# Transport Statement

Land at Church Lane, Lydden

20-045-002 Rev B

**Designer's Response to the Stage 1 Safety Audit**

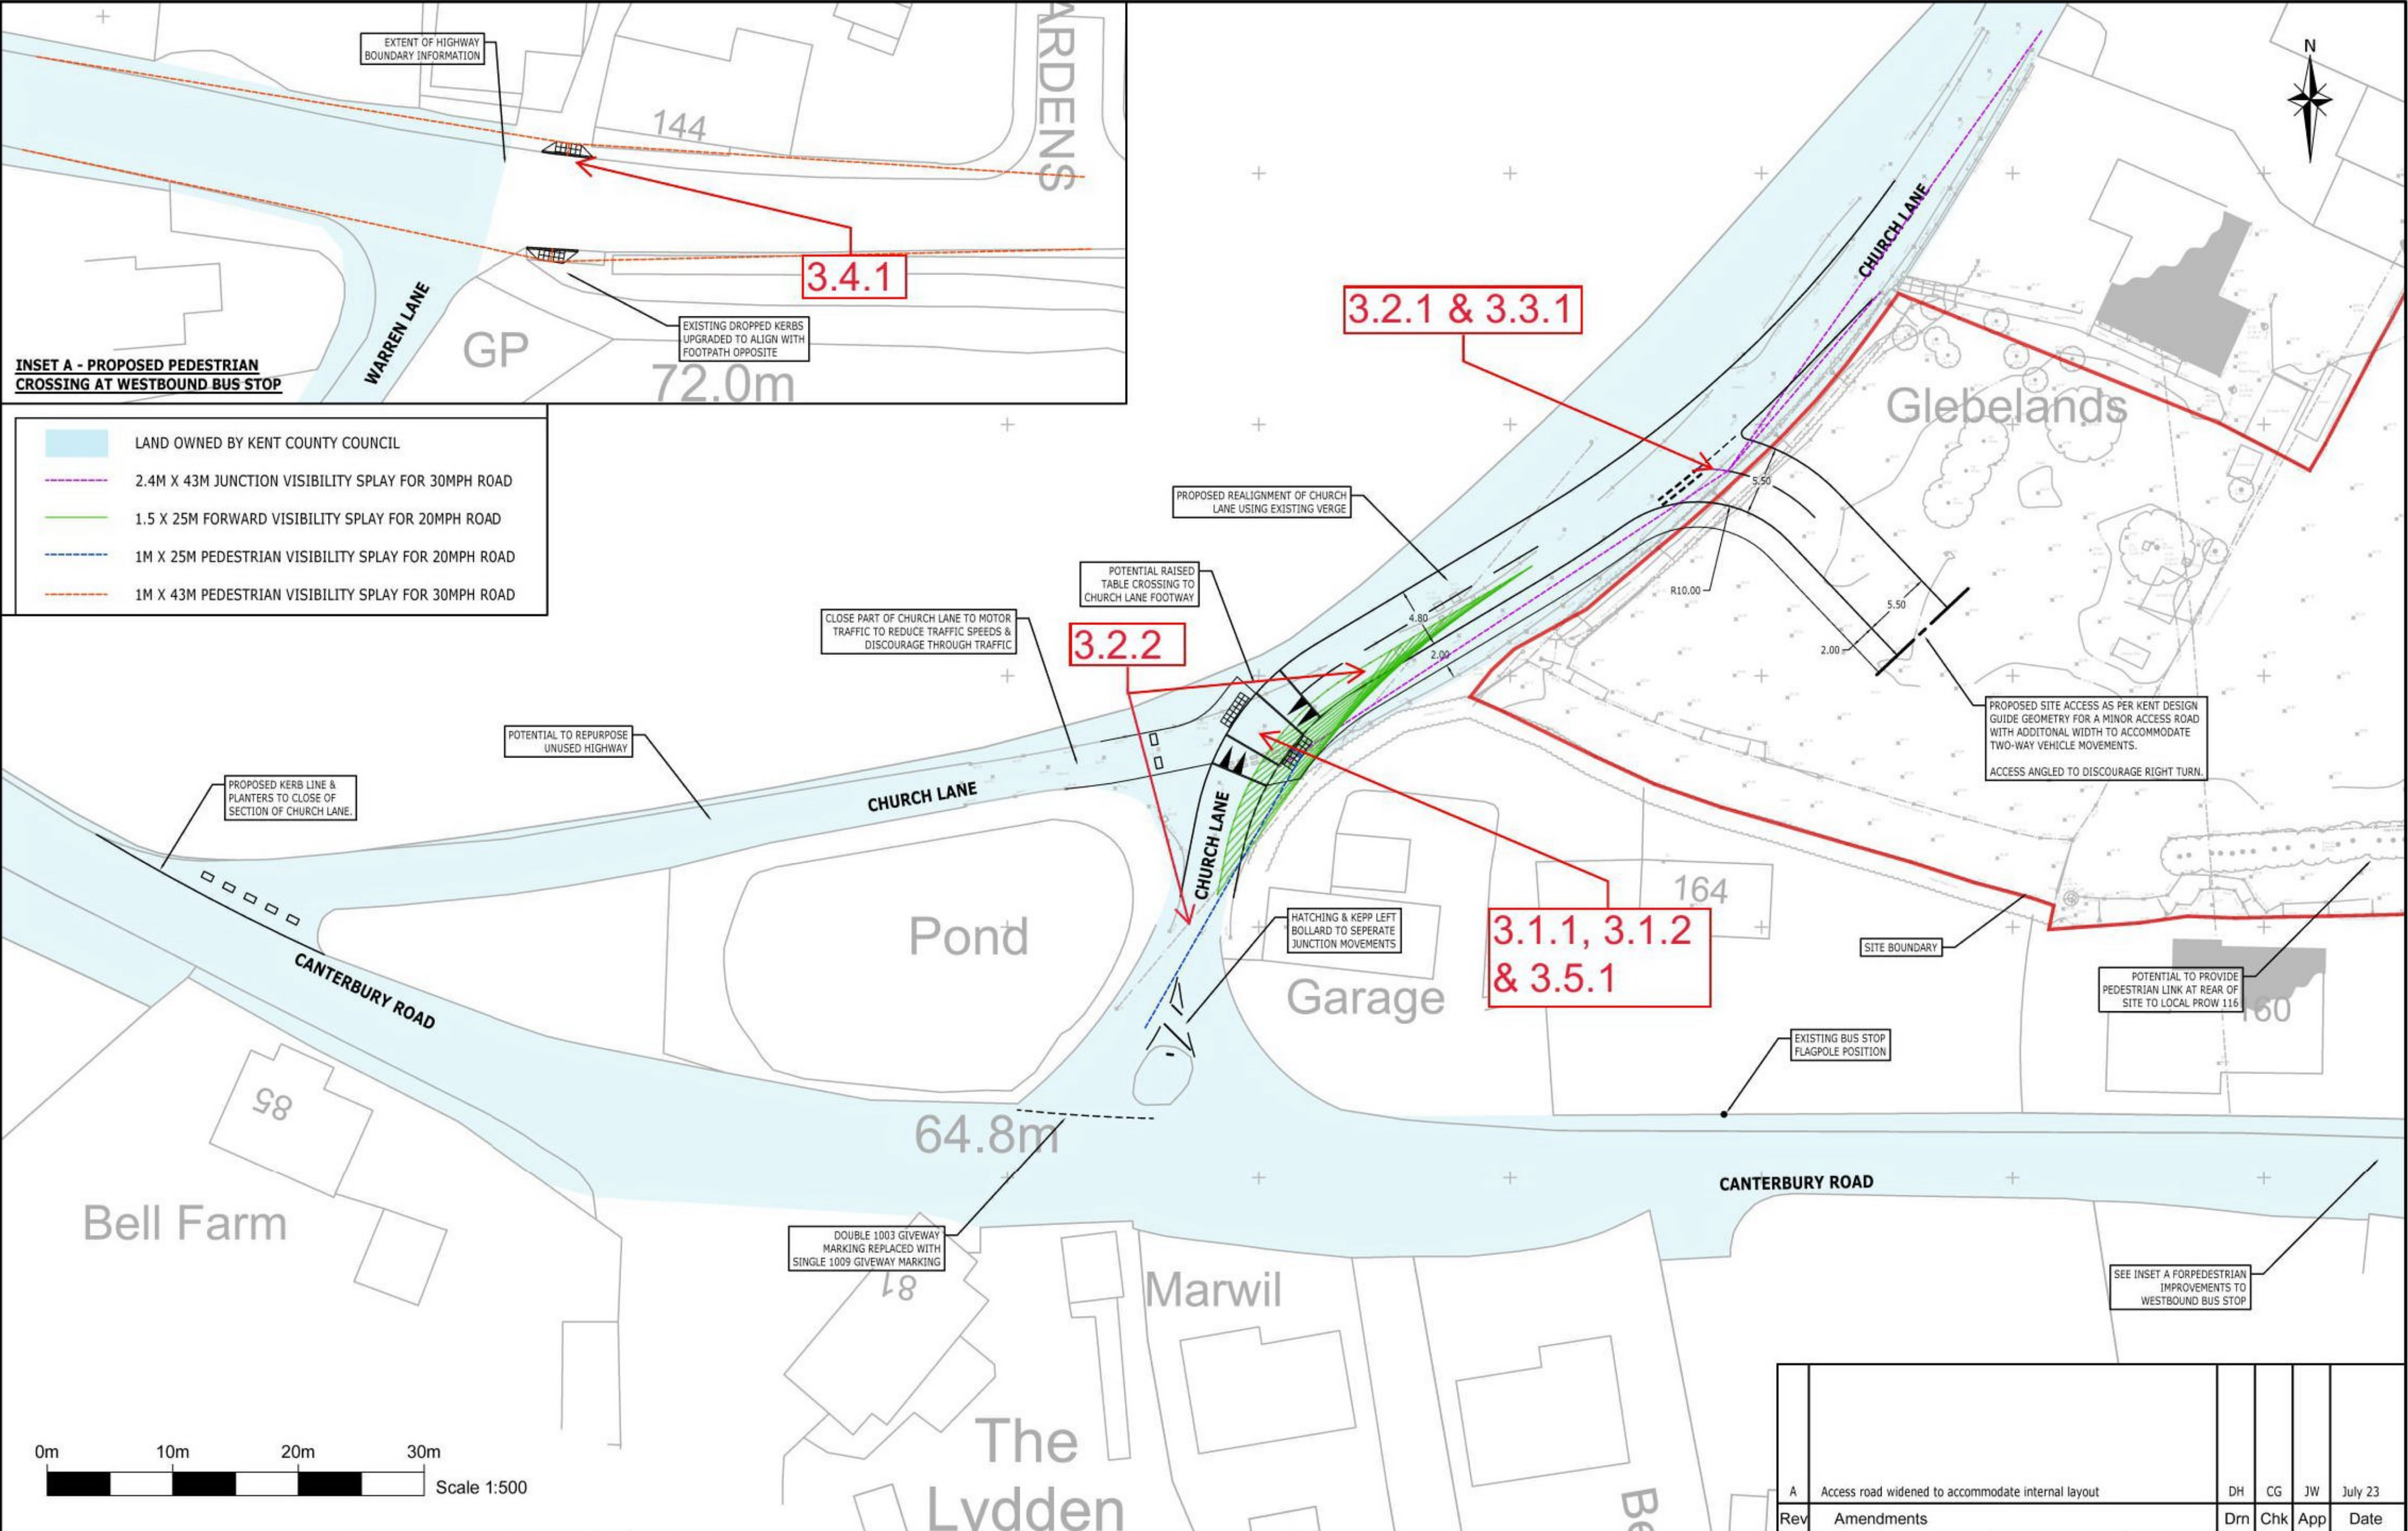
**Location:** Proposed raised table crossing at the access.

**Summary:** Insufficient construction detail on raised table could lead to loss of control collisions.

No details of the ramp profiles or height of humps have been provided for assessment. There is concern that if the height is outside normal ranges, this could lead loss of control collisions, though is recognised that vehicle speeds are likely to be very low.

It is recommended that ramp profiles should be within normal accepted ranges.

**Location:** Proposed raised table crossing at the access.

**Summary:** Ponding could lead to loss of control collisions.

A raised table crossing is proposed; however, the ramps may be a barrier to surface water drainage and could lead to the creation of a low spot. A low spot could lead to ponding and possible loss of control of collisions, particularly in wet or icy conditions, though is recognised that vehicle speeds are likely to be very low.

It is recommended that suitable drainage should be provided.

**Location:** Proposed access with Church Lane.

**Summary:** Reduced visibility could lead to side impact collisions.

The proposed access joins Church Lane where the surrounding land to the southeast drops away. No details have been provided as to how this change in levels is to be accommodated. A slope could impact on visibility distances and additionally give rise to hill starting issues which could lead to hesitation and require longer gaps in traffic to exit safely. Insufficient visibility and a slope could lead to side impact collisions.

It is recommended that the access should be raised to meet Church Lane with a minimal slope, or that a dwell area should be provided, further, that vertical profile details should be provided at Safety Audit Stage 2.

**Location:** Bend on Church Lane.

**Summary:** Vehicles entering the opposing carriageway at bend may lead to side swipe collisions or vehicle to pedestrian collisions.

Swept paths have been provided assessment for the access and the bend. There is concern that a refuse vehicle enters and occupies the opposing carriageway, where two-way vehicle movement would not be possible. Insufficient carriageway space could cause conflict with vehicles travelling in the opposing direction leading to sideswipe collisions, or footway overrun, which could lead to vehicle to pedestrian collisions.

It is recommended that measures including but not restricted to should be taken forward:

- That a priority working system should be employed.
- That the western spur of Church Lane should not be closed, in part, reducing the number of vehicles entering the main junction.

**Location.** Proposed access with Church Lane.

**Summary:** Restricted visibility could lead to side impact collisions or rear end shunts.

There is potential for the northeastern visibility splays to be obstructed by hedgerow, see figure 1 overleaf. Restricted visibility could lead to side impact collisions or rear end shunts.

It is recommended that there should be no physical obstruction of the visibility splays and additionally, that the splays should be periodically maintained to retain visibility.

**Location.** Canterbury Road, proposed pedestrian crossing.

**Summary:** Restricted visibility could lead to vehicle to pedestrian collisions.

The pedestrian / traffic intervisibility splays on the northern side of the carriageway of Canterbury Road are obstructed by on street parking, see figure 2 below. Parked vehicles could mask a child pedestrian at the crossing, where restricted intervisibility could lead to vehicle to pedestrian collisions.

It is recommended that measures should be introduced to control parking at the crossing point.

**Location:** Proposed raised table crossing at the Church lane spur.

**Summary:** Insufficient warning of raised table may lead to loss of control collisions or rear end shunts.

No warning signs have been proposed in advance of the raised table, additionally, this section of Church Lane is only partially lit. Insufficient warning of the raised table, particularly during the hours of darkness could lead to possible loss of control collisions or sudden braking and rear end shunts and be a particular problem for powered two-wheel riders, as the table is located on a bend.

It is recommended that measures including but not restricted to should be taken forward:

- The raised table should be removed and replaced with a conventional pedestrian crossing point.
- 'Road hump' signs, to diagram 557.1 should be installed on the approaches to the raised table and that the table should be sufficiently lit.

Audit Team No.	Audit Team Observation	Audit Team Recommendation	C&A Designers Response	Client Comment
<b>3.1 - General</b>				
3.1.1	<p><b>Location:</b> Proposed raised table crossing at the access.</p> <p><b>Summary:</b> Insufficient construction detail on raised table could lead to loss of control collisions.</p> <p>No details of the ramp profiles or height of humps have been provided for assessment. There is concern that if the height is outside normal ranges, this could lead loss of control collisions, though is recognised that vehicle speeds are likely to be very low.</p>	<p><b>Recommendation:</b> It is recommended that ramp profiles should be within normal accepted ranges.</p>	<p><b>Agree:</b> Ramp gradients and height to be within suitable range for vehicles expected along Church Lane.</p> <p>Details to be provided at stage 2.</p>

3.1.2	<p><b>Location:</b> Proposed raised table crossing at the access.</p> <p><b>Summary:</b> Ponding could lead to loss of control collisions.</p> <p>A raised table crossing is proposed; however, the ramps may be a barrier to surface water drainage and could lead to the creation of a low spot. A low spot could lead to ponding and possible loss of control of collisions, particularly in wet or icy conditions, though is recognised that vehicle speeds are likely to be very low.</p>	<p><b>Recommendation:</b> It is recommended that suitable drainage should be provided.</p>	<p><b>Agree:</b> Suitable drainage to be provided.</p> <p>Details to be provided at Stage 2.</p>

3.2.1	<p><b>Location:</b> Proposed access with Church Lane.</p> <p><b>Summary:</b> Reduced visibility could lead to side impact collisions.</p> <p>The proposed access joins Church Lane where the surrounding land to the southeast drops away. No details have been provided as to how this change in levels is to be accommodated. A slope could impact on visibility distances and additionally give rise to hill starting issues which could lead to hesitation and require longer gaps in traffic to exit safely. Insufficient visibility and a slope could lead to side impact collisions.</p>	<p><b>Recommendation:</b></p> <p>It is recommended that the access should be raised to meet Church Lane with a minimal slope, or that a dwell area should be provided, further, that vertical profile details should be provided at Safety Audit Stage 2.</p>	<p><b>Agree:</b></p> <p>Access road to be designed in accordance with Kent Design Guide gradient parameters to avoid a sharp slope.</p> <p>Levels to be provided at Stage 2.</p>

3.2.2	<p><b>Location:</b> Bend on Church Lane.</p> <p><b>Summary:</b> Vehicles entering the opposing carriageway at bend may lead to side swipe collisions or vehicle to pedestrian collisions.</p> <p>Swept paths have been provided assessment for the access and the bend. There is concern that a refuse vehicle enters and occupies the opposing carriageway, where two-way vehicle movement would not be possible. Insufficient carriageway space could cause conflict with vehicles travelling in the opposing direction leading to sideswipe collisions, or footway overrun, which could lead to vehicle to pedestrian collisions.</p>	<p><b>Recommendation:</b></p> <p>It is recommended that measures including but not restricted to should be taken forward:</p> <ul style="list-style-type: none"> <li>• That a priority working system should be employed.</li> <li>• That the western spur of Church Lane should not be closed, in part, reducing the number of vehicles entering the main junction.</li> </ul>	<p><b>Agree/Disagree:</b></p> <ul style="list-style-type: none"> <li>• Agree - Priority system to be introduced, see drawing 20-045-002_rev B for details.</li> <li>• Disagree – Western spur of Church Lane to remain closed to avoid through traffic, priority system to provide suitable two-way working arrangement.</li> </ul>

3.3 - <u>Junctions</u>				
3.3.1	<p><b>Location:</b> Proposed access with Church Lane.</p> <p><b>Summary:</b> Restricted visibility could lead to side impact collisions or rear end shunts.</p> <p>There is potential for the northeastern visibility splays to be obstructed by hedgerow, see figure 1 overleaf. Restricted visibility could lead to side impact collisions or rear end shunts.</p> <p>Figure 1: Hedgerow in northeastern visibility splay.</p> 	<p><b>Recommendation:</b></p> <p>It is recommended that there should be no physical obstruction of the visibility splays and additionally, that the splays should be periodically maintained to retain visibility.</p>	<p><b>Agree:</b></p> <p>No obstructions within the visibility splays and all hedgerows to be regularly maintained.</p>

<b>3.4 - Non-Motorised User (NMU) Provision</b>				
<b>3.4.1</b>	<p><b>Location:</b> Canterbury Road, proposed pedestrian crossing.</p> <p><b>Summary:</b> Restricted visibility could lead to vehicle to pedestrian collisions.</p> <p>The pedestrian / traffic intervisibility splays on the northern side of the carriageway of Canterbury Road are obstructed by on street parking, see figure 2 below. Parked vehicles could mask a child pedestrian at the crossing, where restricted intervisibility could lead to vehicle to pedestrian collisions.</p> <p>Figure 2: On verge parking at proposed crossing point.</p> 	<p><b>Recommendation:</b> It is recommended that measures should be introduced to control parking at the crossing point.</p>	<p><b>Agree:</b> Pedestrian crossing point built out to improve visibility and reduce vehicle speeds on Canterbury Road.</p> <p>See drawing 20-045/002_Rev B for details.</p>

3.5.1	<p><b>Location:</b> Proposed raised table crossing at the Church Lane spur.</p> <p><b>Summary:</b> Insufficient warning of raised table may lead to loss of control collisions or rear end shunts.</p> <p>No warning signs have been proposed in advance of the raised table, additionally, this section of Church Lane is only partially lit. Insufficient warning of the raised table, particularly during the hours of darkness could lead to possible loss of control collisions or sudden braking and rear end shunts and be a particular problem for powered two-wheel riders, as the table is located on a bend.</p>	<p><b>Recommendation:</b> It is recommended that measures including but not restricted to should be taken forward:</p> <ul style="list-style-type: none"> <li>• The raised table should be removed and replaced with a conventional pedestrian crossing point.</li> <li>• 'Road hump' signs, to diagram 557.1 should be installed on the approaches to the raised table and that the table should be sufficiently lit.</li> </ul>	<p><b>Agree/Disagree:</b></p> <ul style="list-style-type: none"> <li>• <b>Disagree – Raised table to remain as it would provide pedestrian continuity.</b></li> <li>• Agree – Diag 557.1 to be installed on approaches to raised table</li> </ul>
